**Monitoring Report
Year 5
FINAL**

Little Buffalo Creek Stream Mitigation Project

*NCDEQ-DMS Project Number: 94147
Contract Number: 2029
USACE Permit Action ID: 2014-00386
DWR Permit: 14-0129
Cabarrus County*

Subject: DRAFT Monitoring Year 5 report for the
Little Buffalo Creek Stream Mitigation Project
Yadkin River Basin – CU# 03040105– Cabarrus County
DMS Project ID No. 94147
Contract # 002029

Filename: J:\193678-01 Little Buffalo Creek\CAD\Displays\Supplemental Planting Exhibits\Little Buffalo Creek Planting Map.dwg

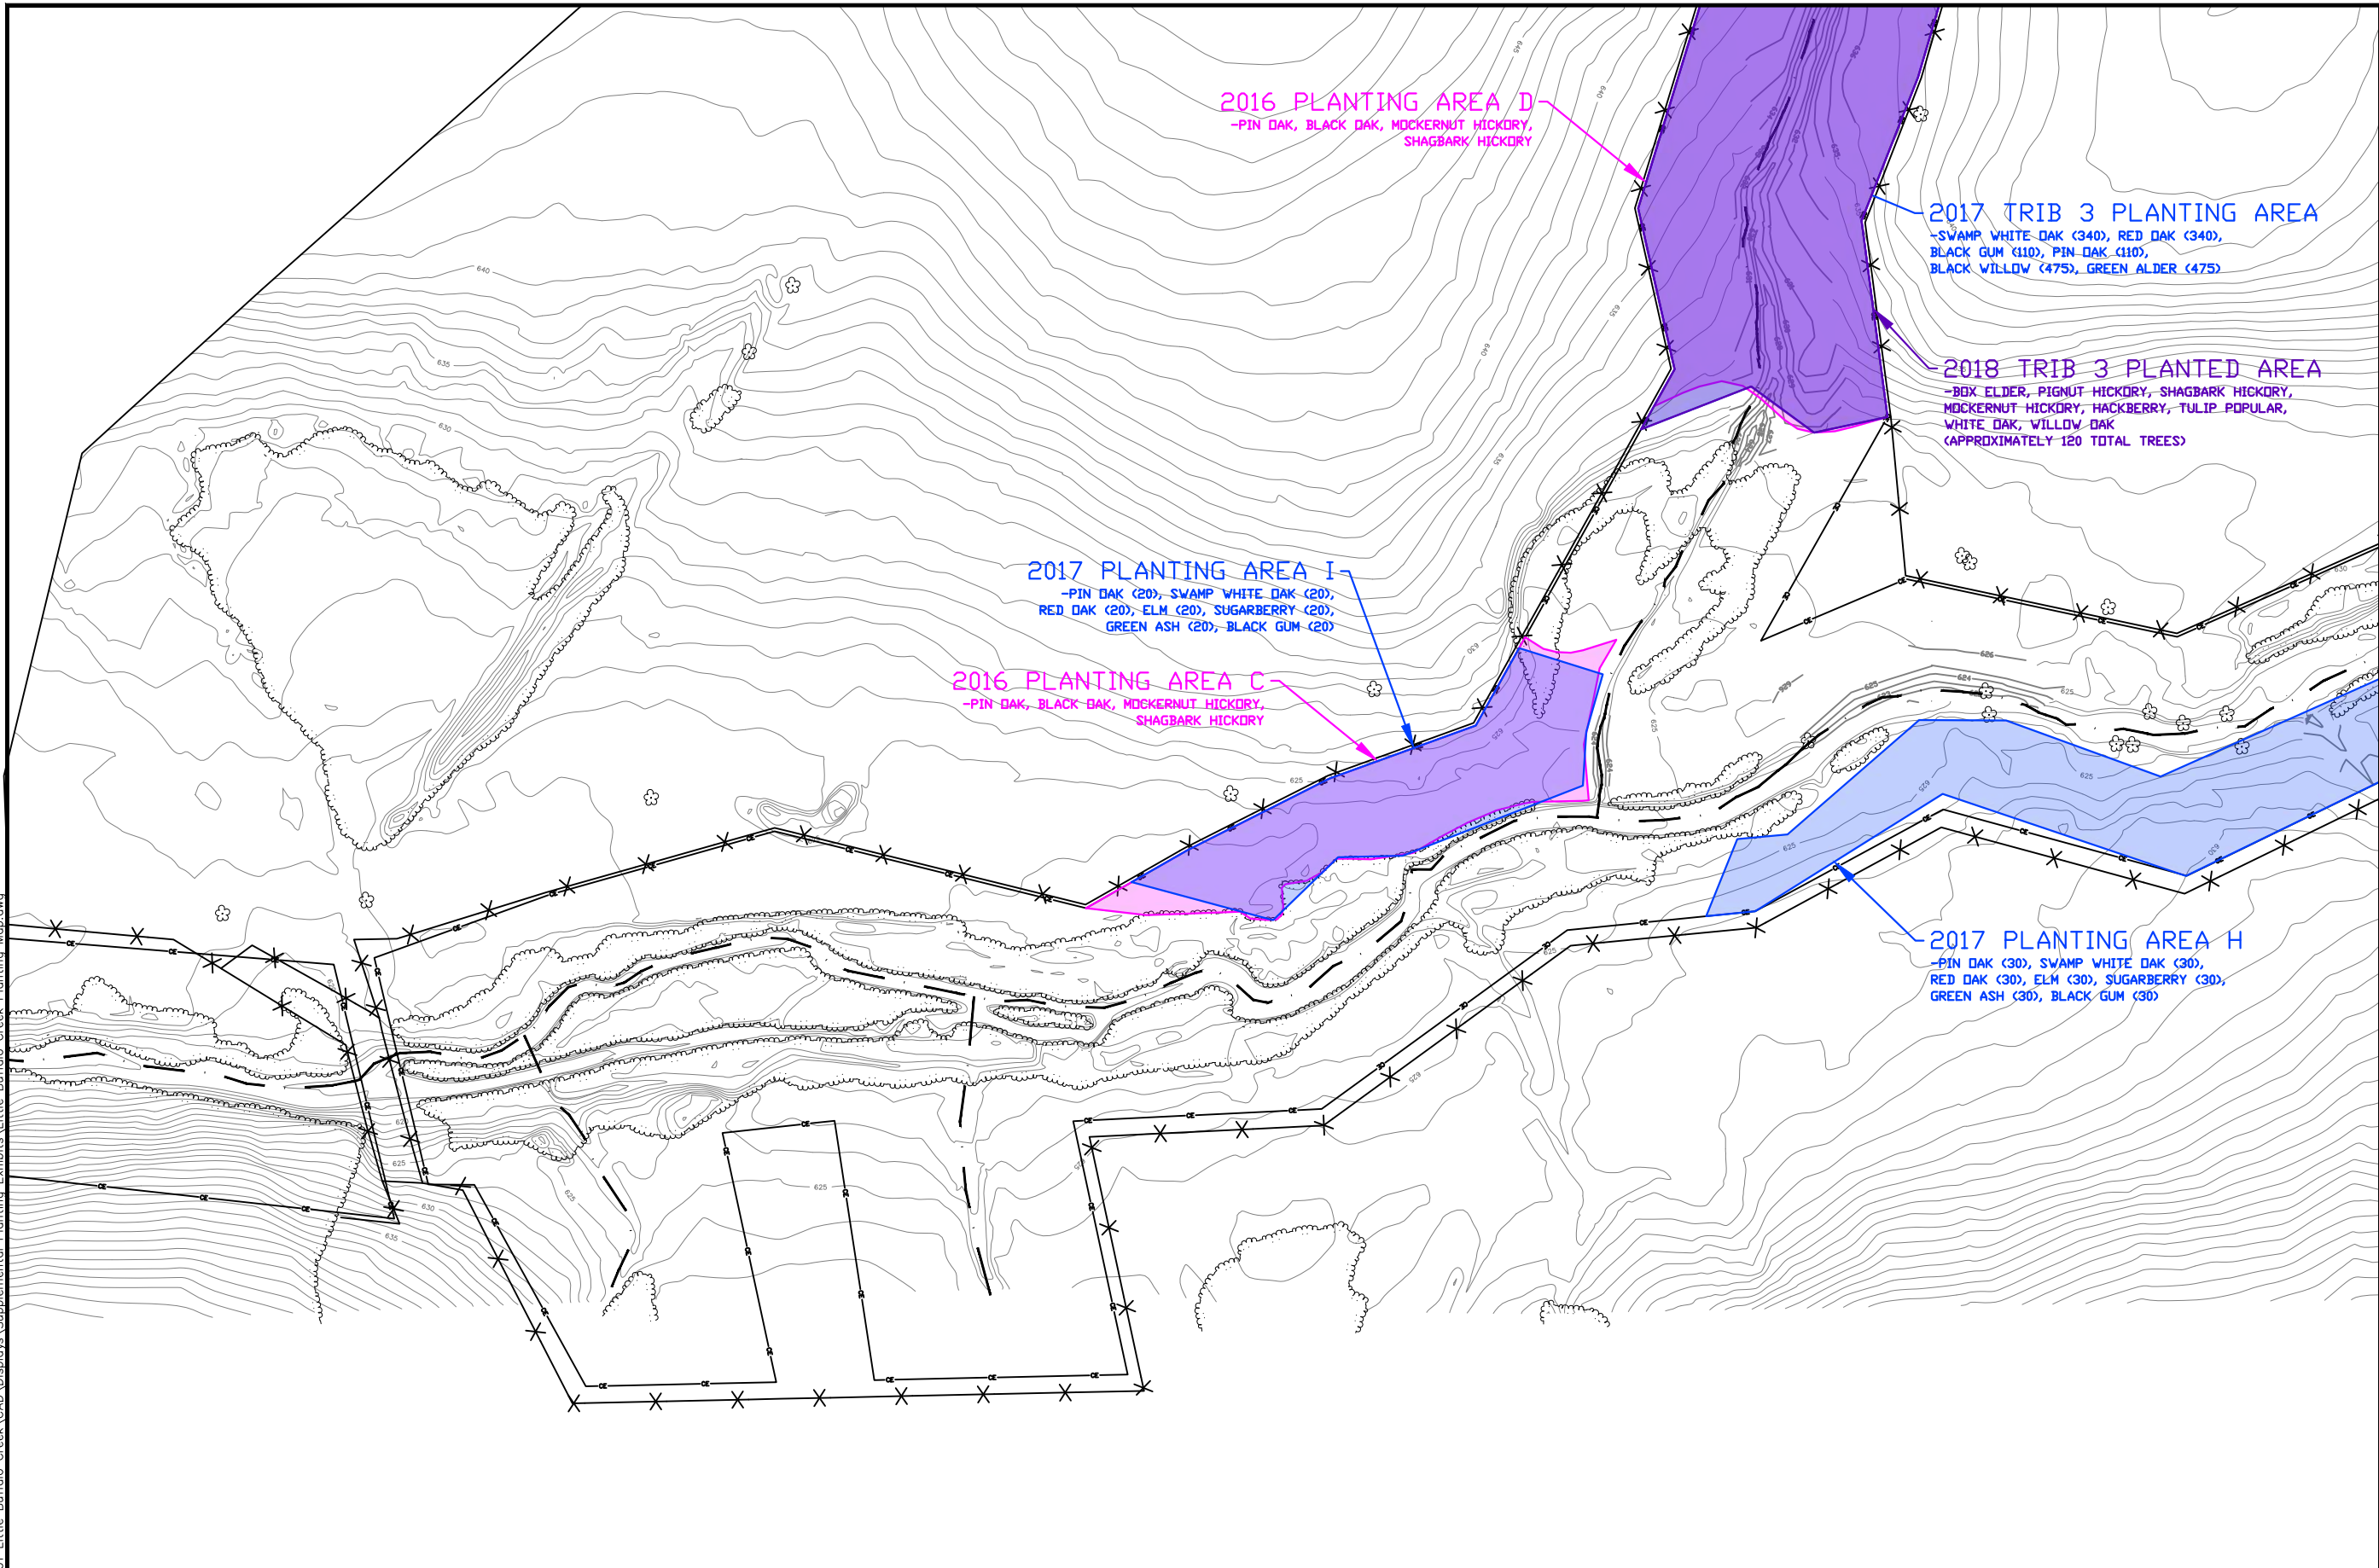
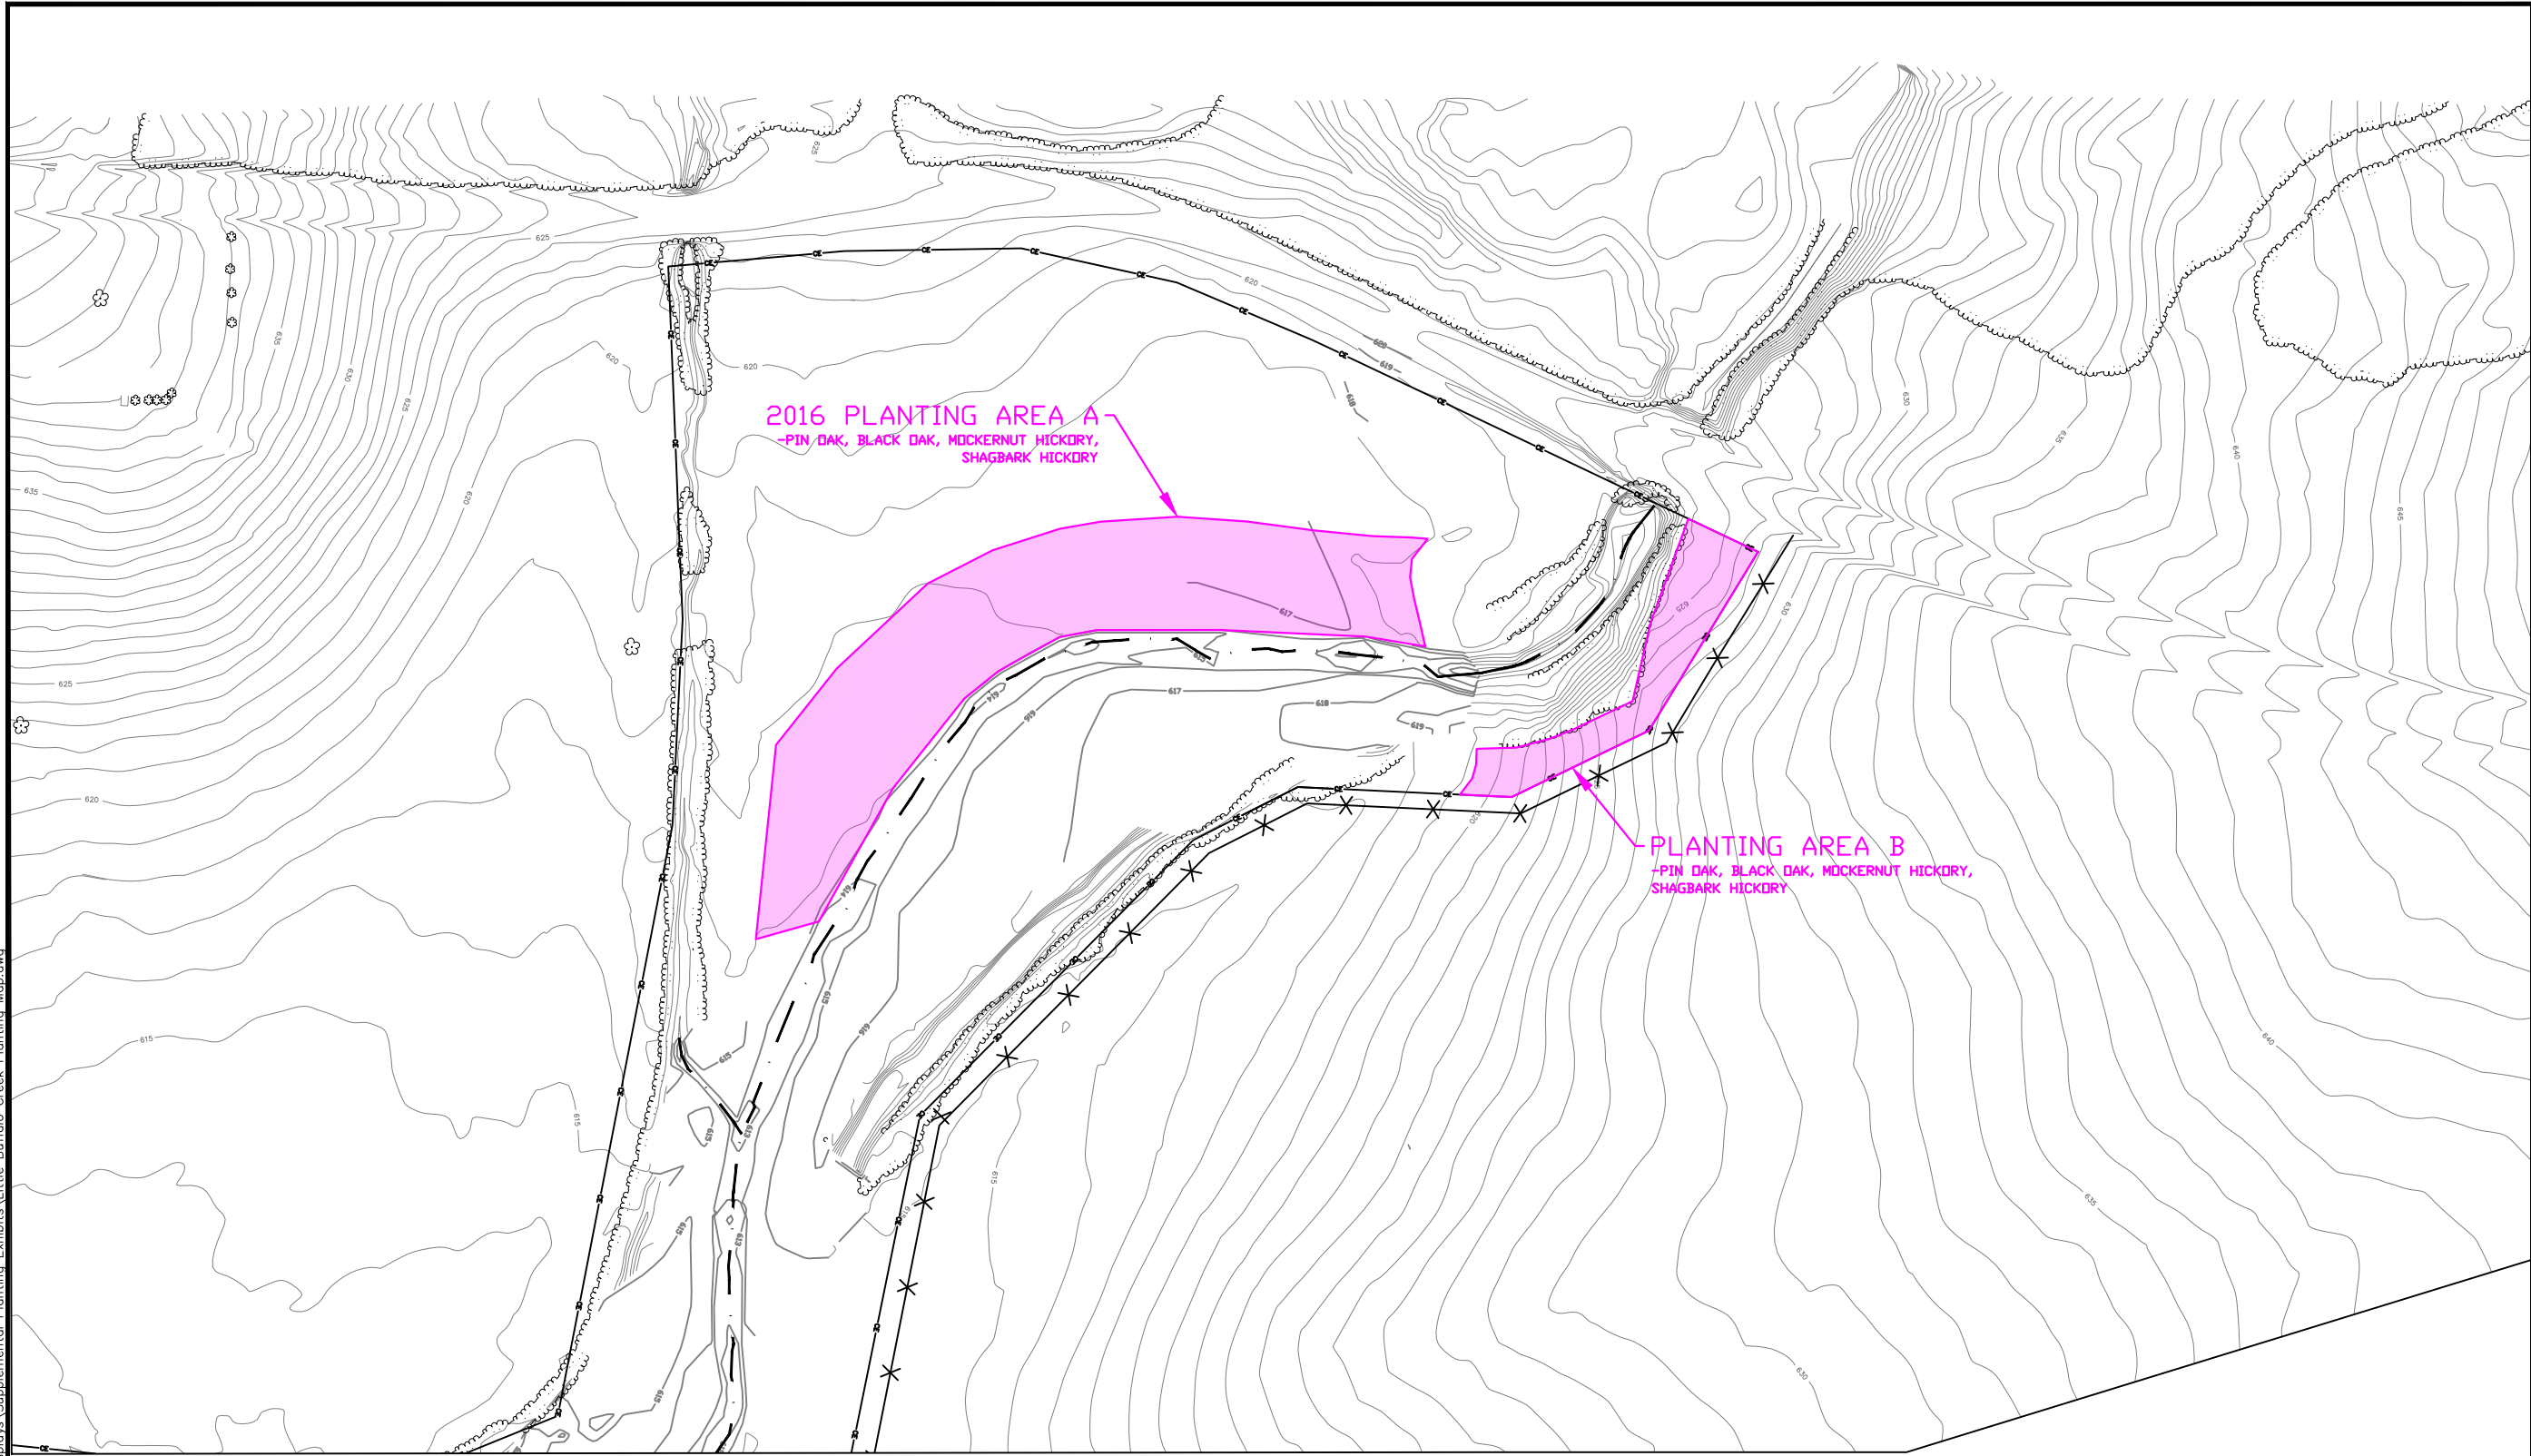
Section 1.5.1.3 - Volunteer Species (Supplemental Plantings): Please describe the placement of the supplemental plantings relative to the vegetation plots and non-plot areas. A supplemental planting map (with planting dates) would be helpful and at a minimum should be provided in the project closeout report.

- *WSP added text in section "1.5.1.6 Additional Tree Planting" of the Monitoring Year 5 report that describes locations of supplemental plantings from February 2016, March 2017, and November 2018. A map depicting these planting locations and dates has been included in Appendix F. This map will also be included in the project closeout report.*
